Amendments to the Drawings:

Appl. No. 09/825,903 Amdt. Dated January 13, 2005 Reply to Office action of September 28, 2004 Annotated Sheet Showing Changes Sheet 2 of 2

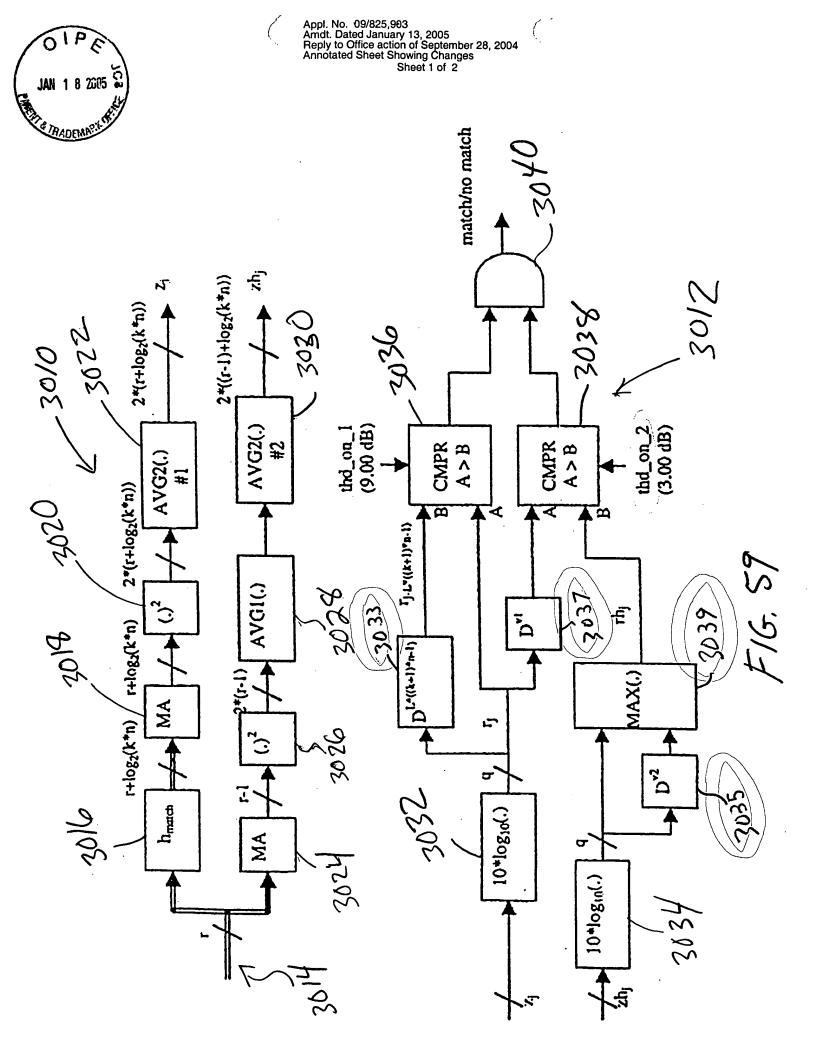
The Examiner has objected to the Drawings under 37 C.F.R. § 1.83(a) as failing to show every feature specified in the claims. In particular, the Examiner has objected to the steps of "delaying," "multiplying," and "comparing" in lines 14 - 21 of Claim 1, as well as in lines 23 - 34 of Claim 9, and the further steps of "multiplying," and "comparing" in lines 26 - 31 of Claim 1, as well as in lines 39 - 48 of Claim 9, as not being shown in the Drawings. The Examiner has furthermore objected to the "plurality of log operands" featured in Claims 8 and 9 as not being shown in the figures.

Regarding the step of "delaying," Fig. 59 shows three delay functions 3040, 3042, 3044 (3033, 3035, 3037 after amendment), also described on page 92 in lines 5 - 15 of the specification. The step of "delaying" claimed in Claim 1, lines 14 - 15, is reflected in delay function 3040 (3033 after amendment). Claim 9 has been cancelled.

Regarding the steps of "comparing," Fig. 59 shows two compare functions 3036, 3038, also described on page 91, line 32 through page 92, line 19. The step of "comparing" in Claim 1,

lines 19 - 21, is reflected in compare function 3036. The step of "comparing" in Claim 1, lines 29 - 31, is reflected in compare function 3038. Claim 9 has been cancelled.

The attached sheets of drawings in the appendix hereto include changes to Fig. 59 and Fig. 80. These sheets, which include Fig. 59 and Fig. 80, replace the original sheets including Fig. 59 and Fig. 80.
